Access Compliance Report

Public Rights-of-Way

Intersection ID: 10798	Main Street: W_5TH_ST	Cross Street: N_BRUNS_AV	Location: S
ADA ID: 9B234ECA8F12	Ramp Type: ParaDiag	Initial Pass/Fail: Fail	Overall Compliance: No
			Severity Score: 26.25

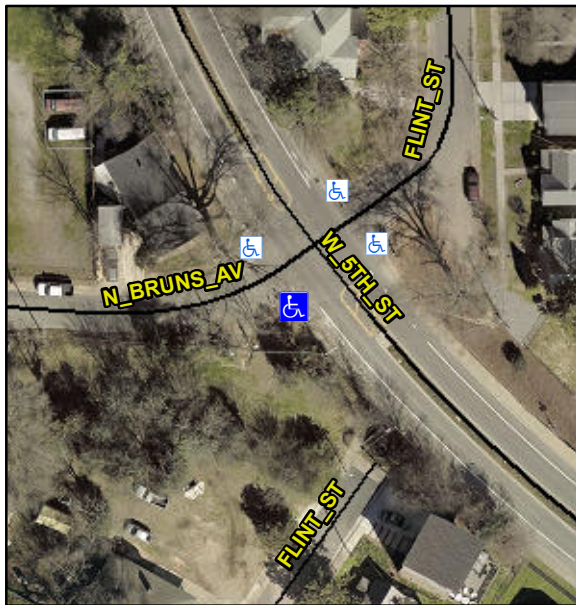
LT RP < 5%

R304.5.3, R304.3.2

Compliance	Description	Data	Compliance	Description	Data
N/A	Ramp Length LT (in)	45.0	N/A	Ramp Length RT (in)	62.0
Yes	Ramp Width LT (in)	48.0	Yes	Ramp Width RT (in)	48.0
Yes	Ramp Slope LT (%)	4.7	No	Ramp Slope RT (%)	14.0
No	Ramp XSlope LT (%)	2.8	No	Ramp XSlope RT (%)	2.7
N/A	Landing Length (in)	N/A	N/A	DWS Provided?	N/A
N/A	Landing Width (in)	N/A	N/A	DWS Contrast?	N/A
N/A	Landing Slope (%)	N/A	N/A	DWS Length (in)	N/A
N/A	Landing X Slope (%)	N/A	N/A	DWS Full Width?	N/A
N/A	Landing Curb? (Y/N)	N/A	N/A	DWS Offset (in)	N/A
N/A	Shared Landing?	N/A			
N/A	Gutter Ponding?	N/A	N/A	Gutter Slope (%)	N/A
N/A	Gutter Lip Ht (in)	N/A	N/A	Gutter X Slope (%)	N/A
N/A	Painted X Walk1?	No	N/A	Painted X Walk2?	No
	X Walk 1 Direction	To NE		X Walk 2 Direction	To NW
N/A	X Walk 1 Width (in)	N/A	N/A	X Walk 2 Width (in)	N/A
	X Walk 1 Slope (%)	1.7		X Walk 2 Slope (%)	7.6
	X Walk 1 X Slope (%)	5.8		X Walk 2 X Slope (%)	3.6
N/A	Ramp inside XWalk1?	N/A	N/A	Ramp inside XWalk2?	N/A

Remove & Replace Curb Ramp With Two New Directional Ramps or Equivalent.
